Service Letter No. 373

SUBJECT: Installation of Oil Shields on Airborne Mechanisms Dry Vacuum Pumps, Models 113A1 and 113A5

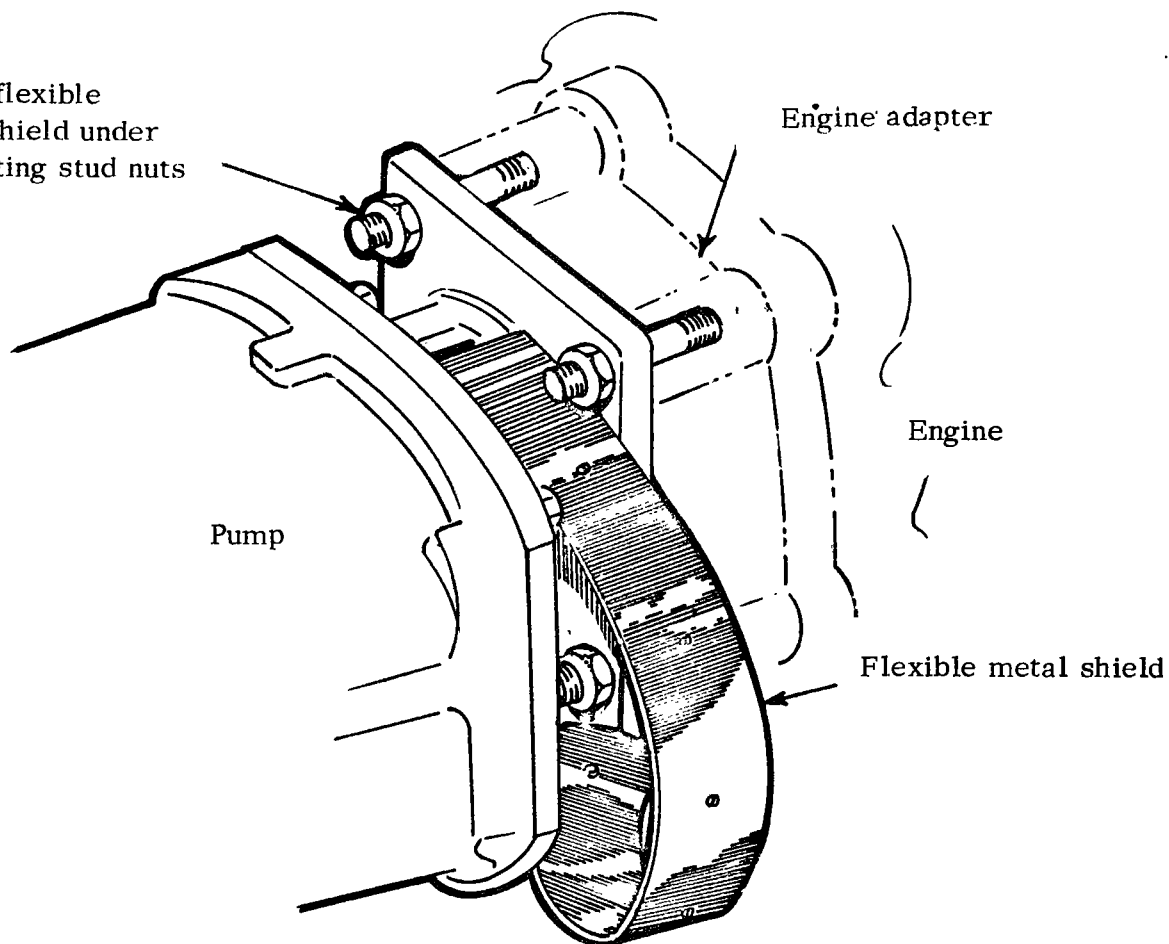
It has been determined that occasionally oil or cleaning solvents have entered the ventholes in the face of the mounting flange of the 113A1 and 113A5 Airborne Mechanisms dry vacuum pump.

A flexible metal shield, part number 756 143, which is easily installed by threading under the pump mounting bolts, has been designed to protect these openings. Removing the pump is not necessary and the shield does not require fastening as the spring tension of the shield will hold it in its proper position, once installed. Installation of this shield is recommended on the subject aircraft equipped with Airborne Mechanisms Dry Vacuum Pumps. See sketch on the reverse side of this letter.

Install flexible
metal shield under
4 mounting stud nuts

Vent holes to be
covered by flexible
metal shield
